A27 EAST OF LEWES

DETAILED MODIFICATION MOD-2

THE HIGHWAYS ENGLAND (A27 TRUNK ROAD EAST OF LEWES IMPROVEMENT SCHEME) (SHARED USE PATH) (SIDE ROADS) ORDER 2019

DETAILED MODIFICATION No.2

Site Plan 11:

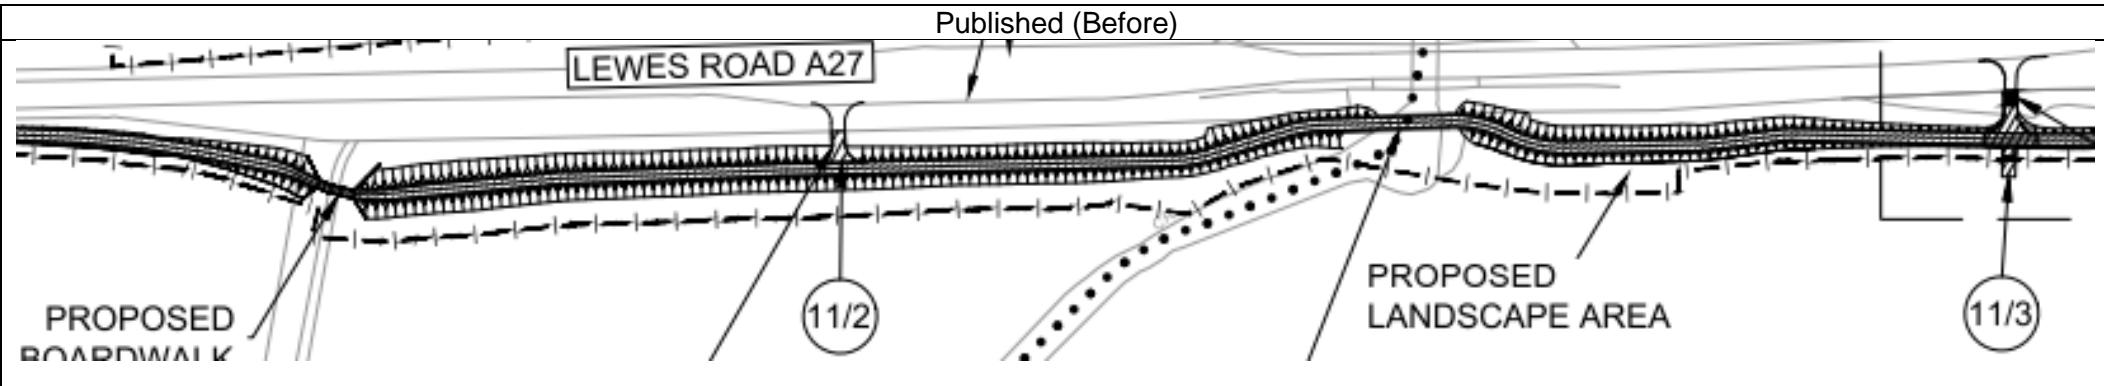
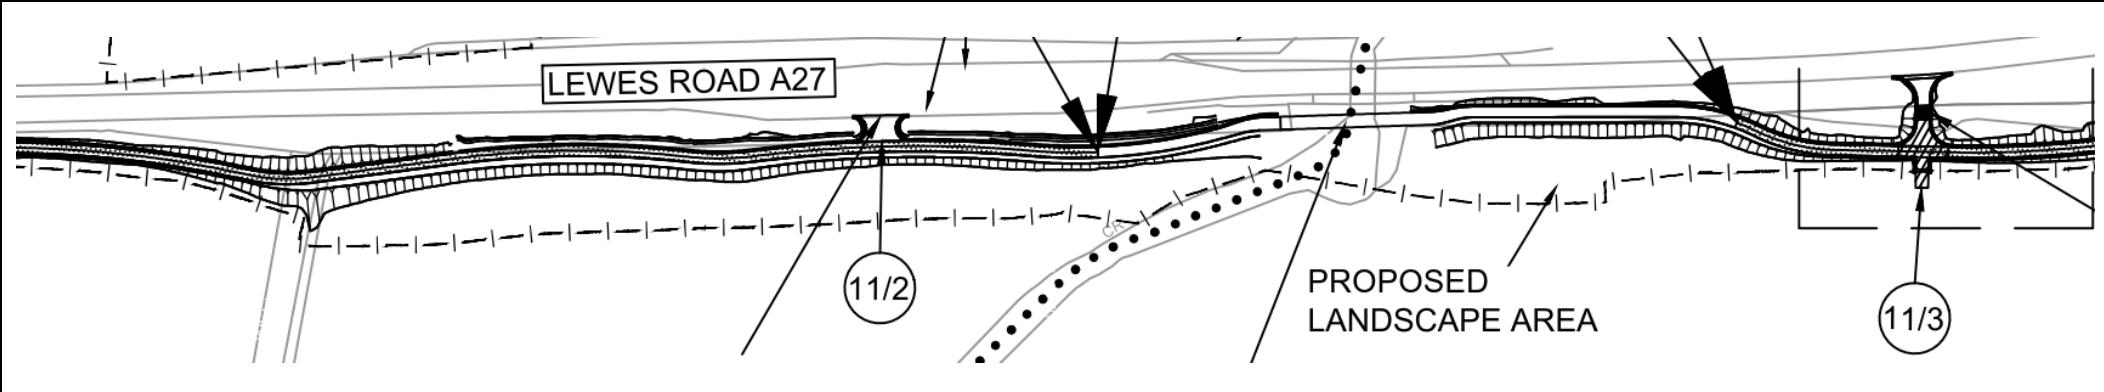
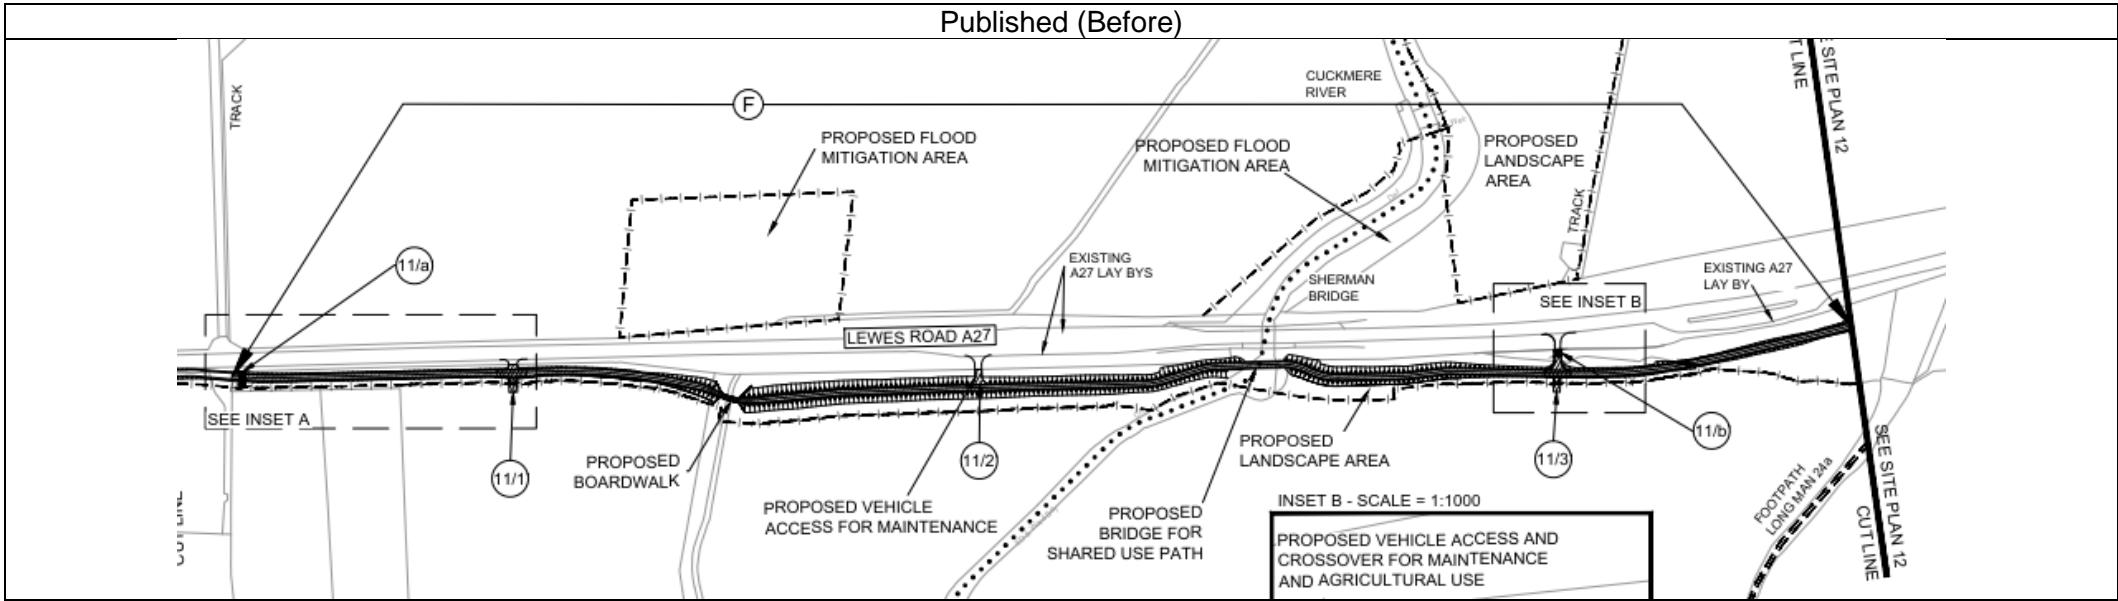
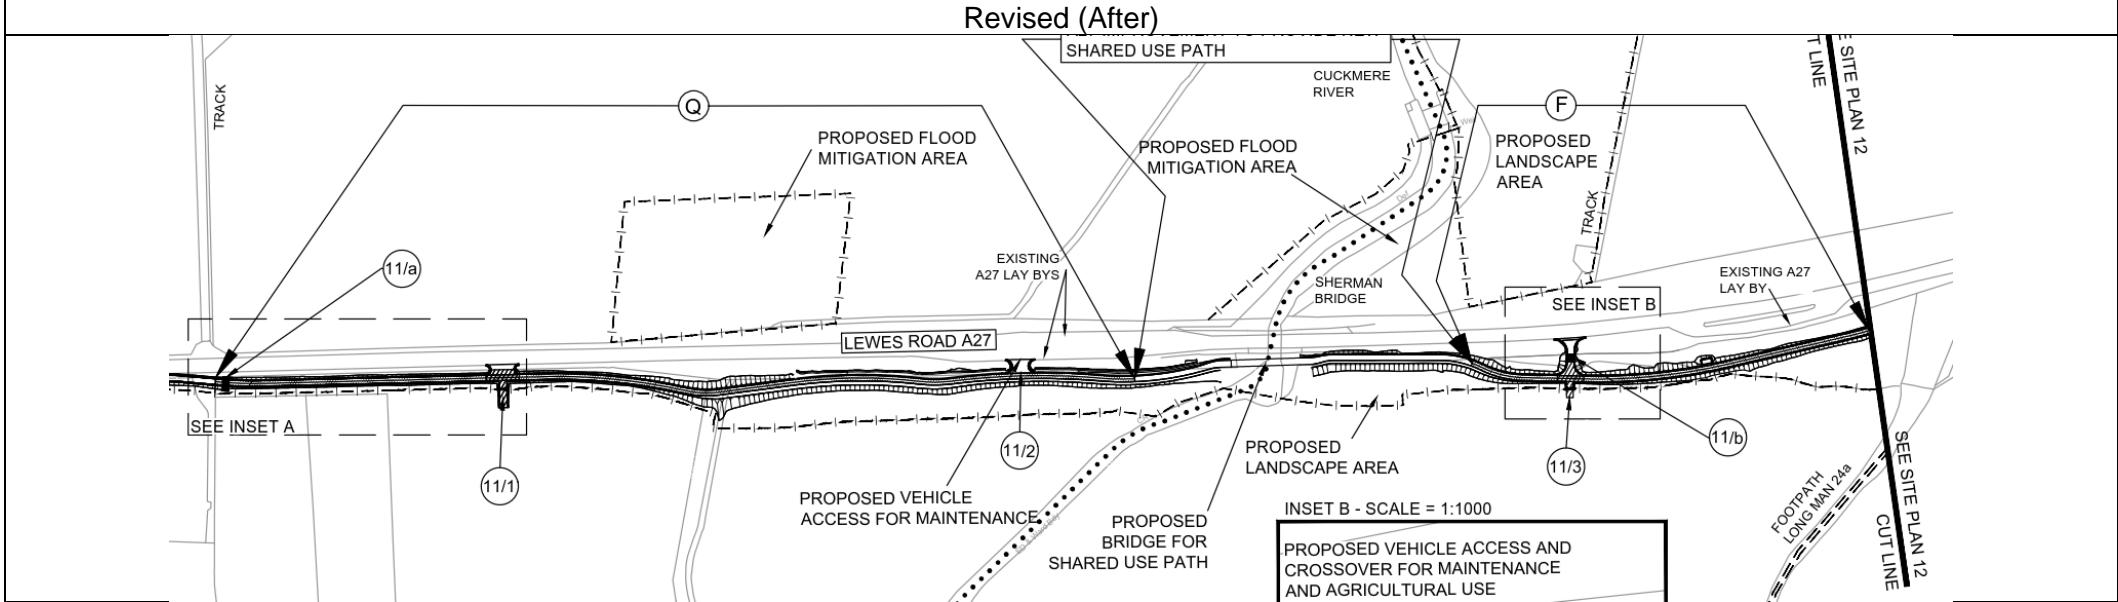
30. Amendment of “New Highway to be provided” reference “F” (including hatch and leader) to reflect revised design (reduced extent of reference F). Section of route reference F replaced with Reference Q and “A27 improvement to provide new shared use path” to reflect revised design.
31. Amendment (relocation) of PMA reference 11/2 to reflect revised design.
32. Removal of proposed boardwalk.

Site Plan 12:

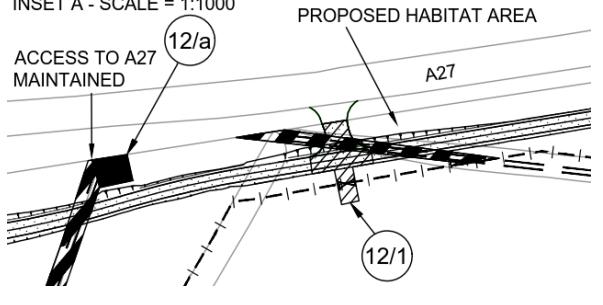
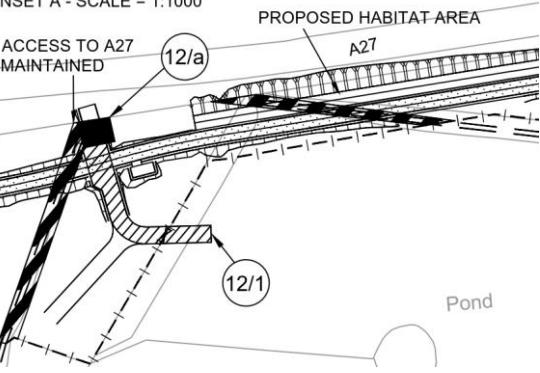
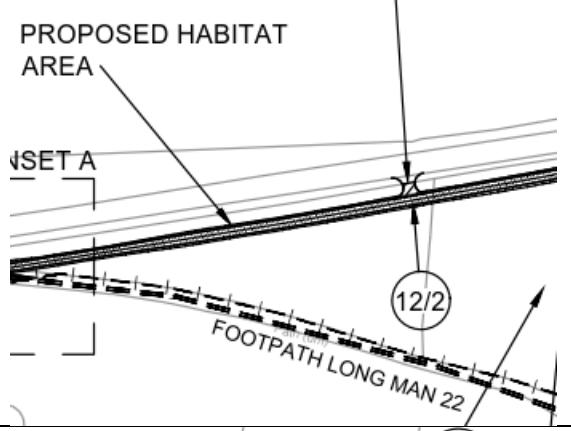
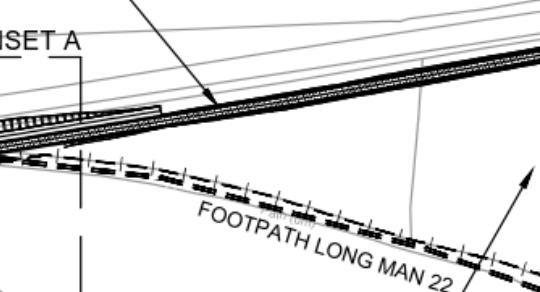
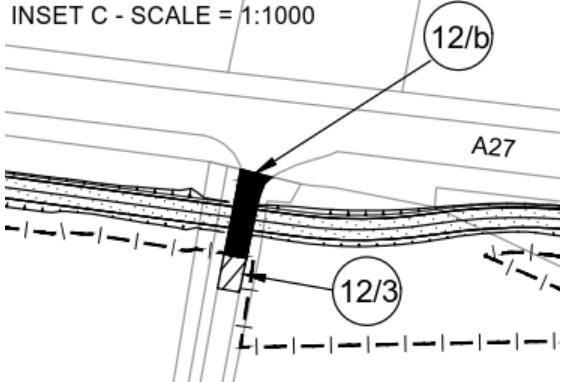
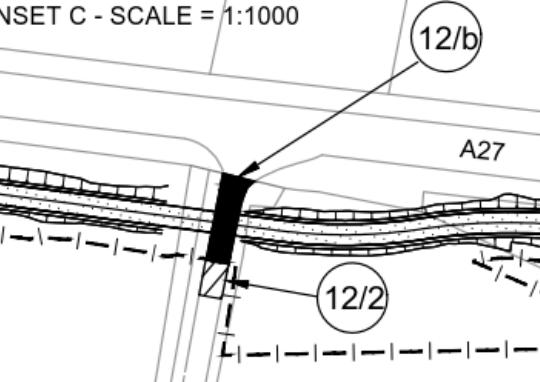
33. Amendment (relocation) of PMA reference 12/1 to reflect revised design.

34. Removal of PMA (for maintenance use) reference 12/2.

35. "PMA 12/3" revised to "PMA 12/2" as a consequence of item 34 above.

Site Plan 13:

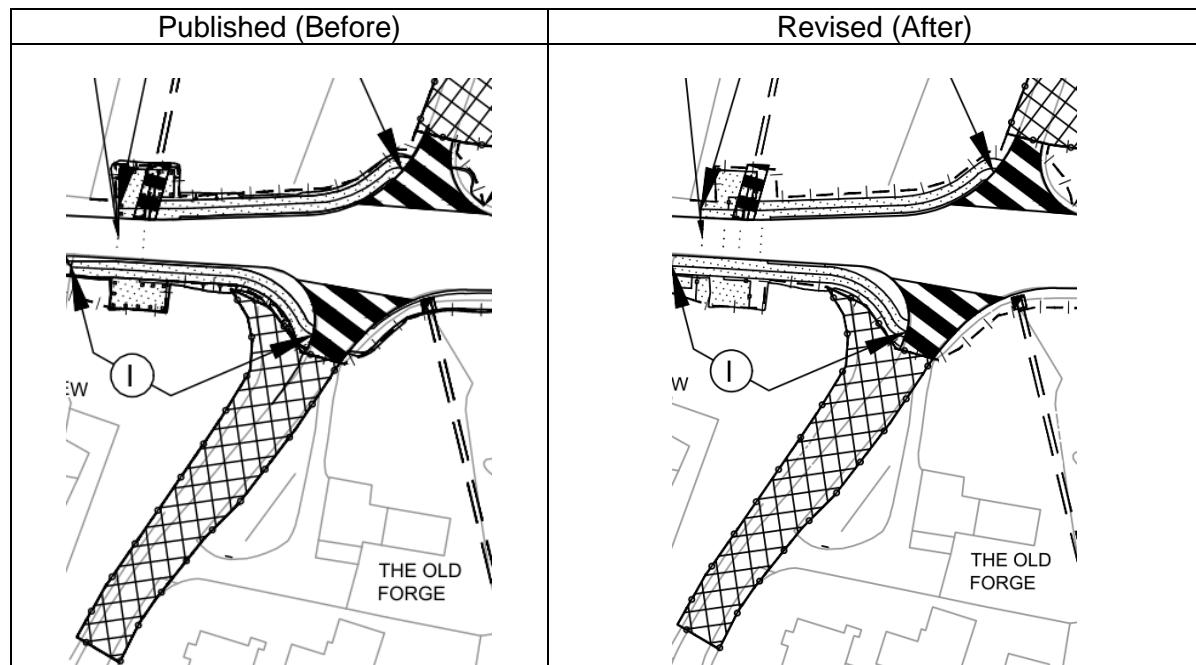
36. Error amendments to CPO boundary near Wilmington junction.

Site Plan 14:

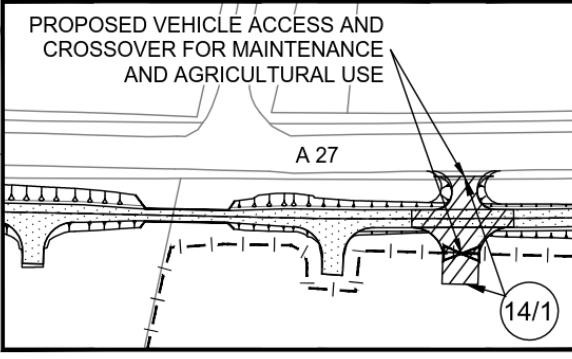
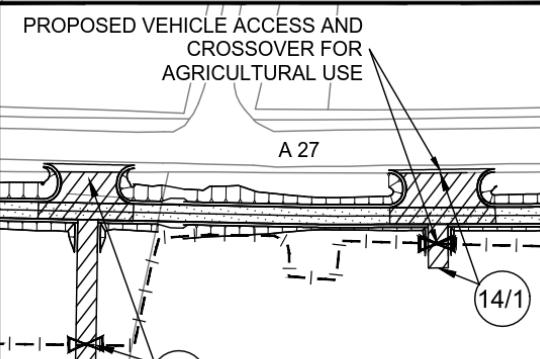
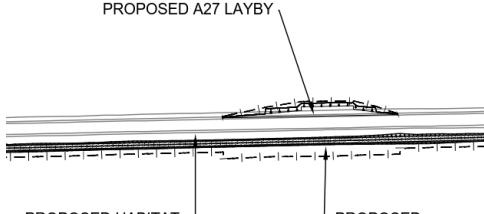
37. Removal of two proposed turning heads for maintenance vehicles.
38. Removal of proposed boardwalk location.
39. Removal of proposed A27 layby.
40. Addition of new PMA reference 14/3.

Site Plan 15:

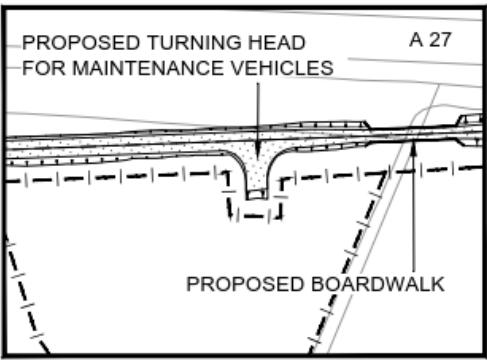
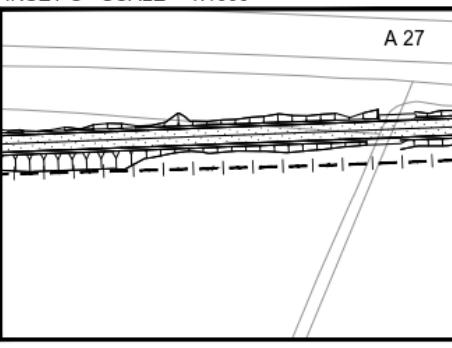
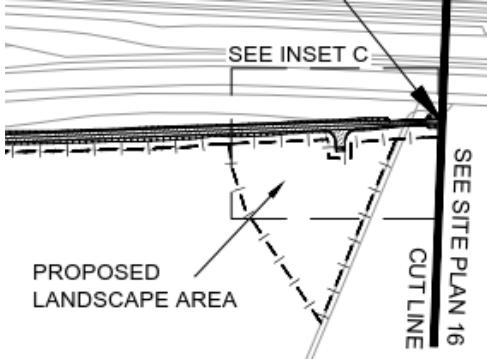
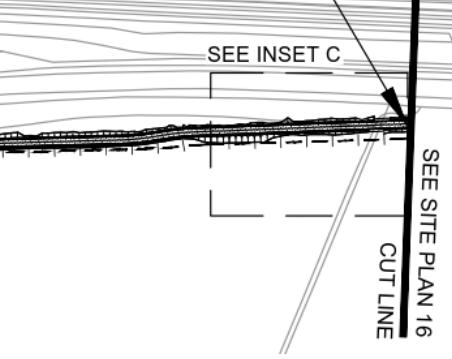
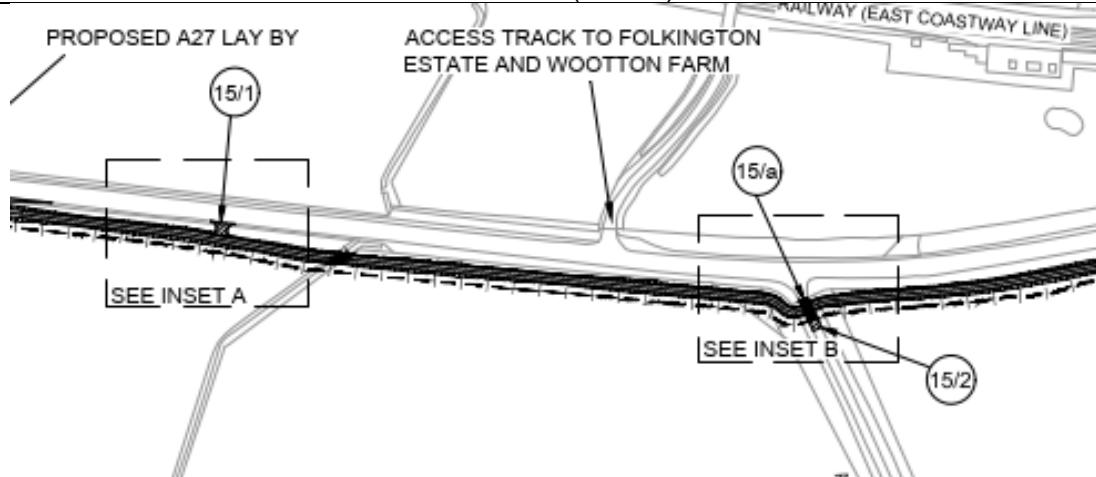
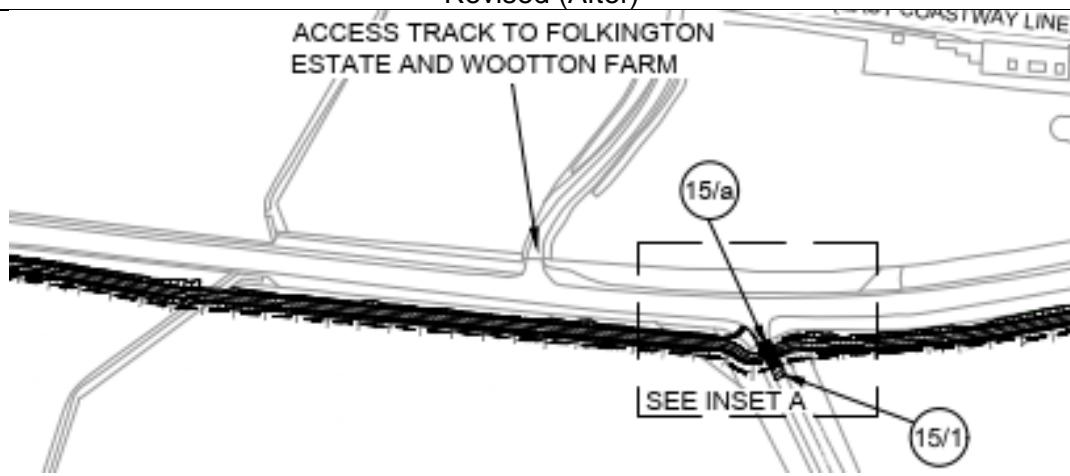
41. Removal of one proposed turning head for maintenance vehicles.
42. Removal of proposed boardwalk location.
43. Removal of proposed landscape area.
44. Amendments to CPO boundary near Inset C.
45. Removal of PMA (maintenance use) reference 15/1.
46. "PMA 15/2" revised to "PMA 15/1" as a consequence of item 45 above.

Site Plan 16:

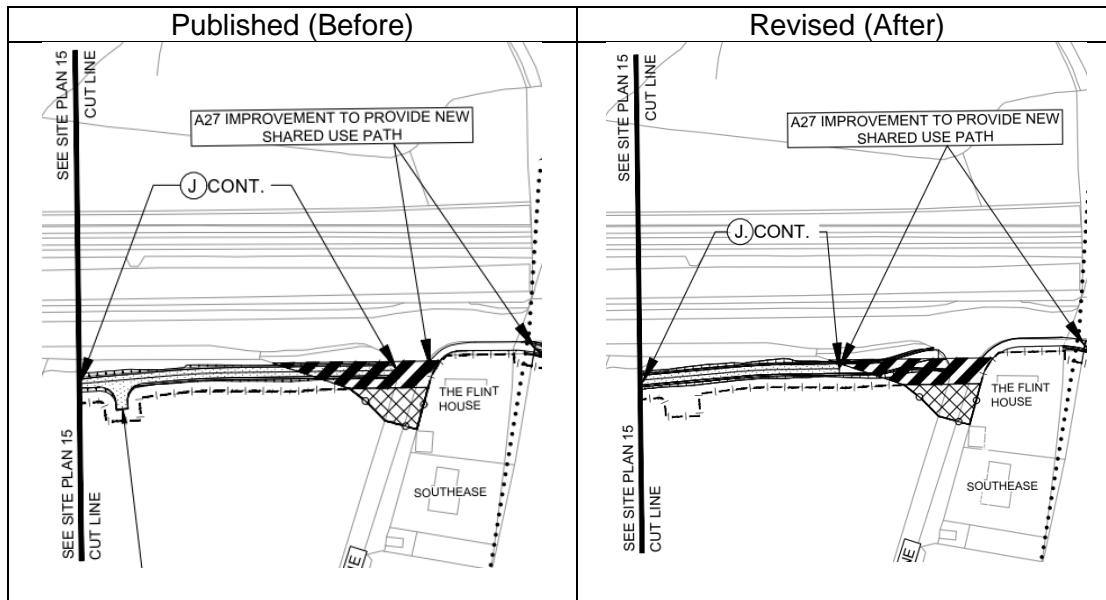
47. Correction of "New Highway to be provided" extents reference J.
48. Removal of one proposed turning head for maintenance vehicles.

Site Plan 17:

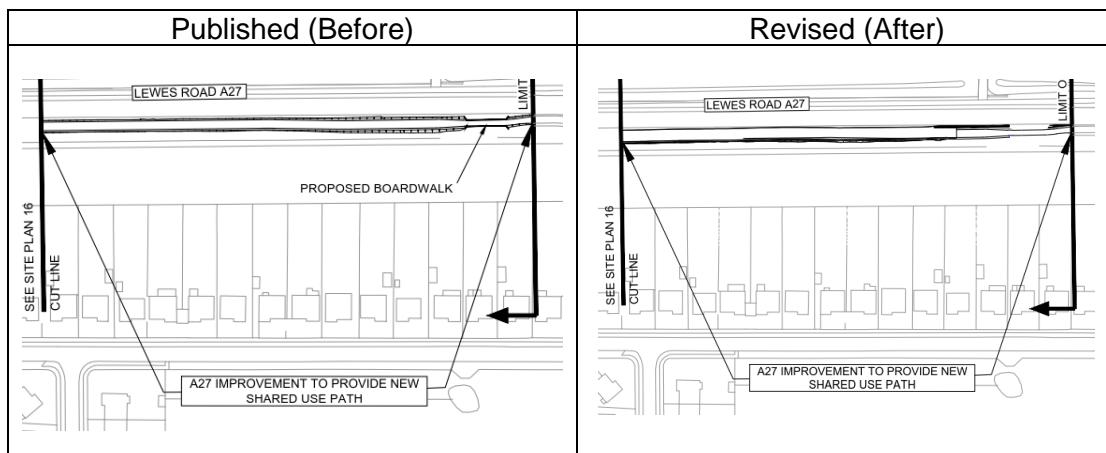
49. Removal of proposed boardwalk.
